PLAN COMMISSION AMENDED

Wednesday, October 08, 2025 – 6:30 PM

AGENDA

Re: Plan Commission review & recommendation on an amendment to the Future Land Use Map of the Town of Clayton Comprehensive Plan 2040 submitted by Vierbicher on behalf of the Town of Clayton in the area immediately South of US Hwy 10 between Clayton Ave and Fairview Rd, being Tax ID #006-0347-01; Tax ID #006-0344; Tax ID #006-0345; and Tax ID #006-0339-06

Proposed Clayton Ridge Comp Plan Amendment

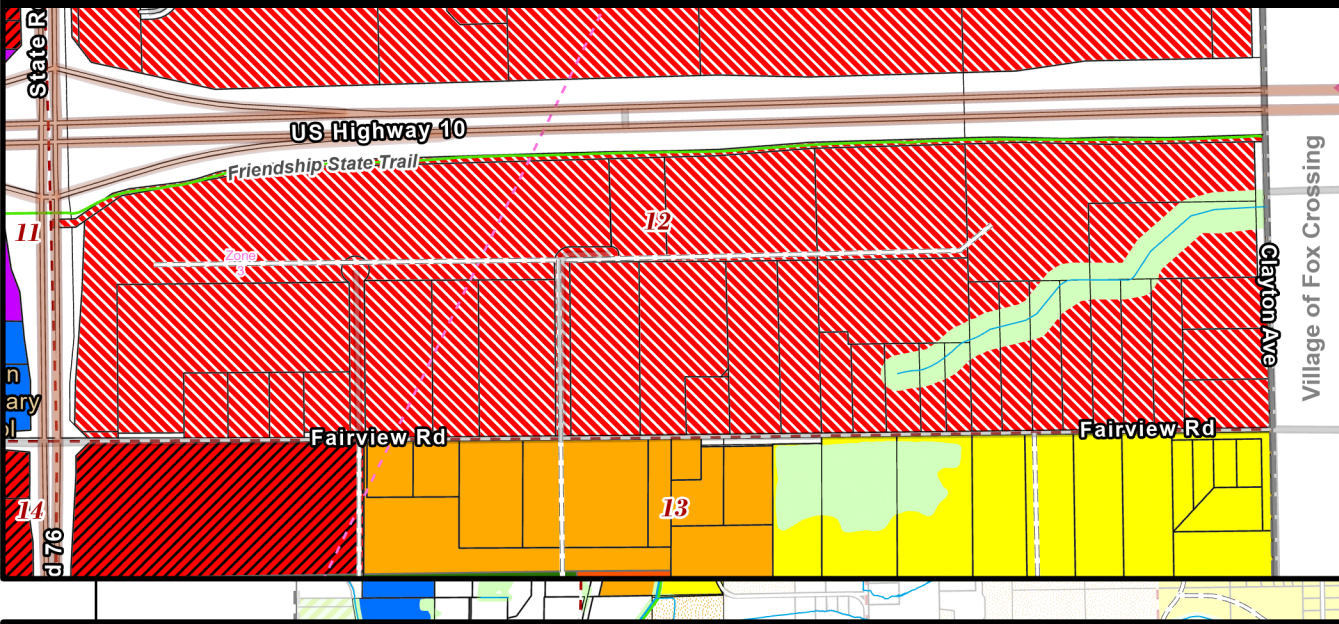
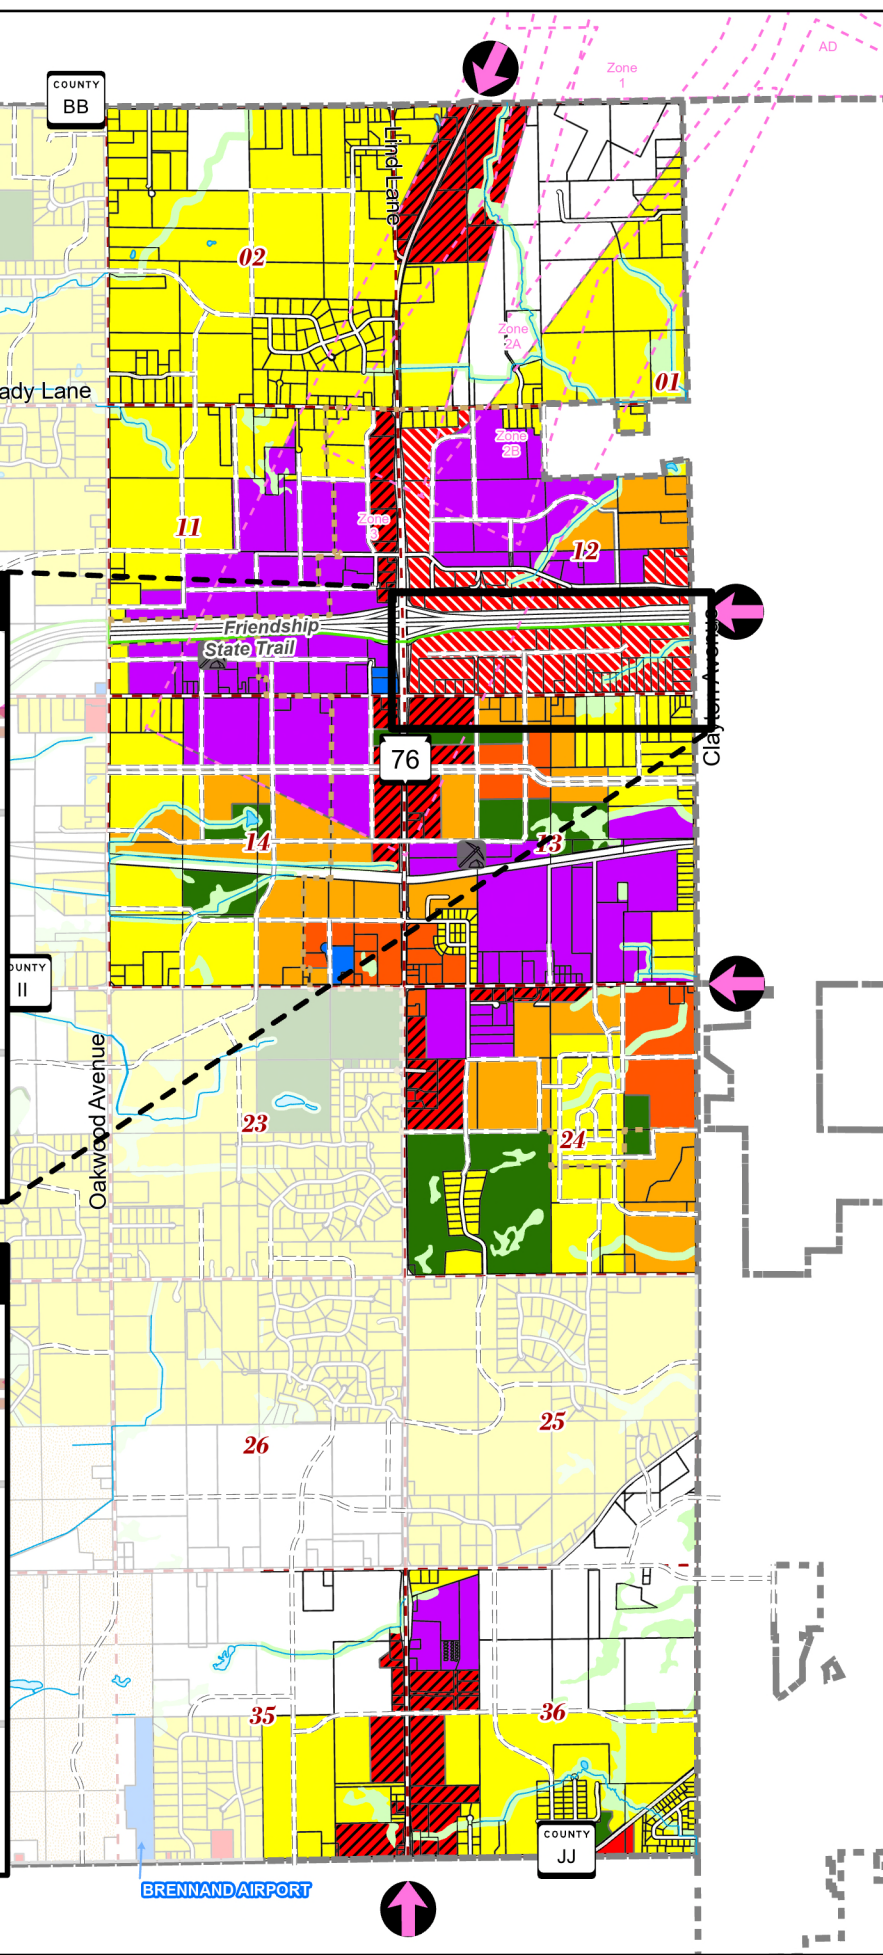
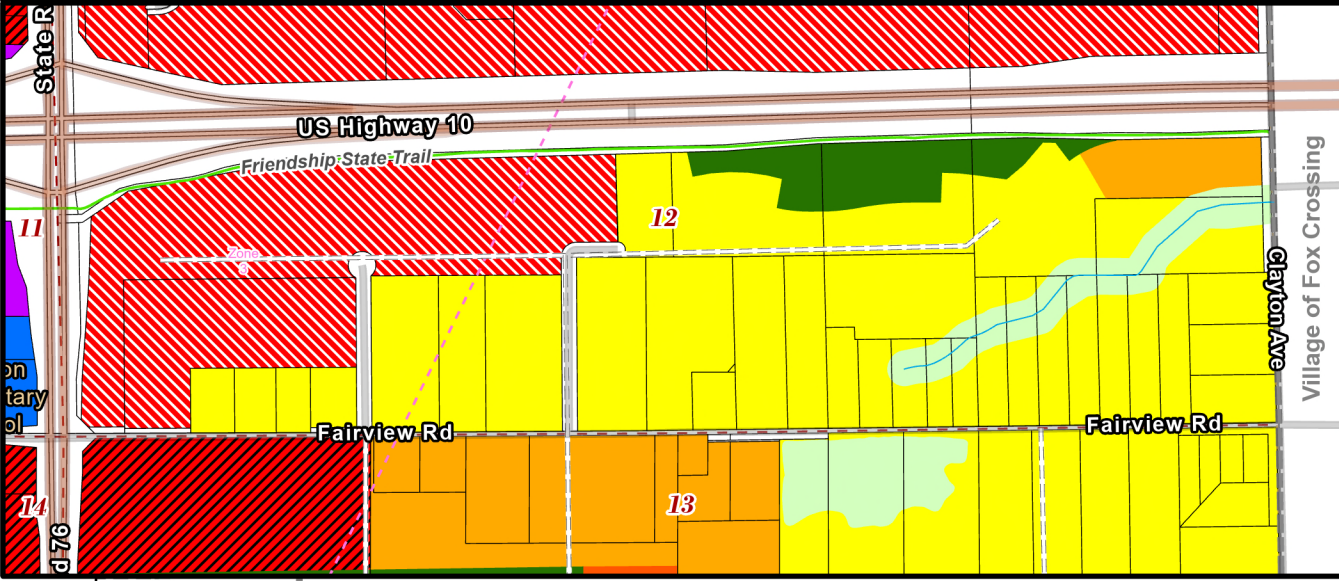
The Comprehensive Plan amendment requested by the applicant is to amend the Future Land Use map to change the area from Business Park to Residential (both single/duplex and medium/high densities) and designate parks and recreation category lands along the Friendship Trail / USH 10 right-of-way.

Amending the Future Land Use map would not further the Town's goal to develop this corridor land into a regional professional hub. A large portion of the Economic Development chapter of the Comprehensive Plan would need to be revised if this amendment is adopted.

Residential uses along a major thoroughfare like USH 10 are not consistent with the goals to provide housing in locations home buyers will find attractive. The proposal prioritizes single-family developments, which does not support the goal for a mix of housing types and higher density developments. While there is likely intent for new multifamily buildings on the lands adjacent to Clayton Avenue, a strictly residential

The Friendship Trail is adjacent to the property and provides a connection to the developing core of the Fox Valley area. The dedicated greenspaces in the proposal are almost entirely unbuildable lands best left fallow, as they are mostly protected wetlands with minimal development potential. These facts indicate that while this development plans to allow access to the existing Trail corridor, the proposal does not add usable public greenspace to the proposed neighborhood and therefore does not meet the goal of adequate public greenspace within residential developments.

SURVEYED FOR:
LANDMARK REAL ESTATE
AND DEVELOPMENT
Drawing No. P-2662

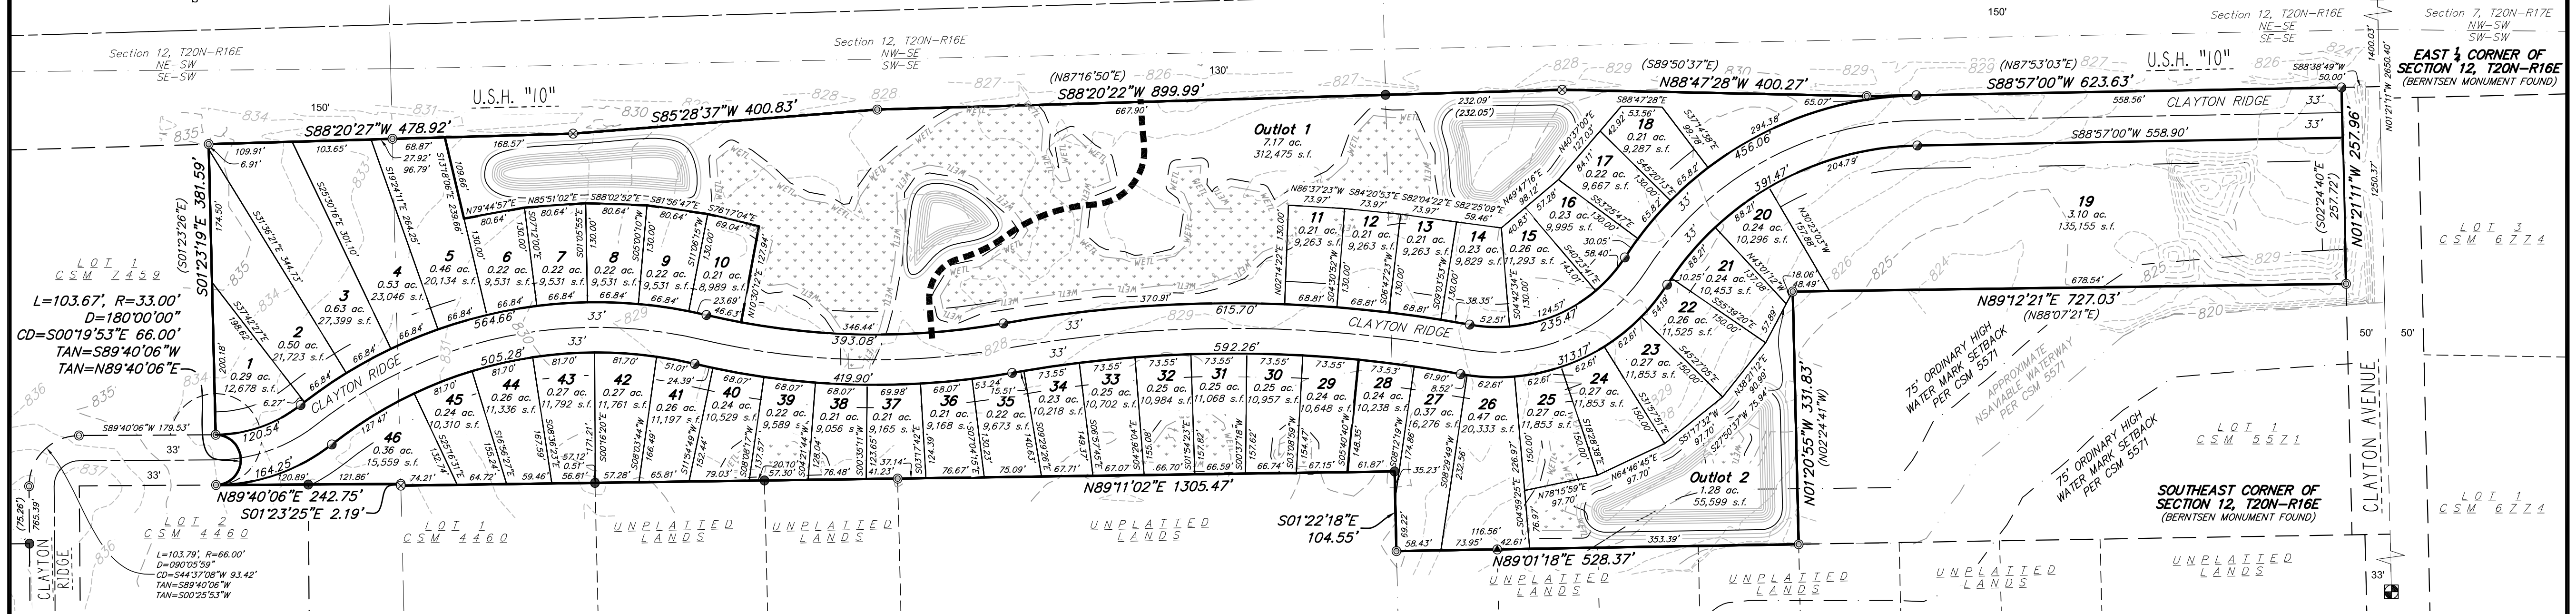
The Town of Clayton has a Subdivision Ordinance that governs the review of land divisions and plats. Within this ordinance, section 7.10.14. documents the minimum information required for a preliminary plat submission. This ordinance requires consistency with the Comprehensive Plan and Future Land Use Map, as well as Zoning ordinance and map. If either request ahead of this failed on an approval recommendation, the preliminary plat is not consistent with all Town regulations and cannot be approved.

Stormwater management plans – Section 7.10.05(4) requires stormwater management plans to be submitted “for review and comment at the time of preliminary plat submittal for major subdivisions...”. No plans were received beyond the site plan designating the stormwater pond locations.

If both the Comprehensive Plan amendment and the rezone request were recommended for approval, this plat would still be recommended for denial. The recommended changes to the plat are large enough to no longer be considered substantially consistent with the original plans. By statute, final plats are entitled to approval if they are substantially consistent with approved preliminary plats.

1. Additional lands are dedicated to the public for park space. A concept plan for those park areas would be required as well.
2. Lots impacted by wetland delineations are redrawn to minimize limitations to future property owners and their use of the property.
3. Mixed use zoning is considered to create walkable neighborhoods with services and business opportunities.
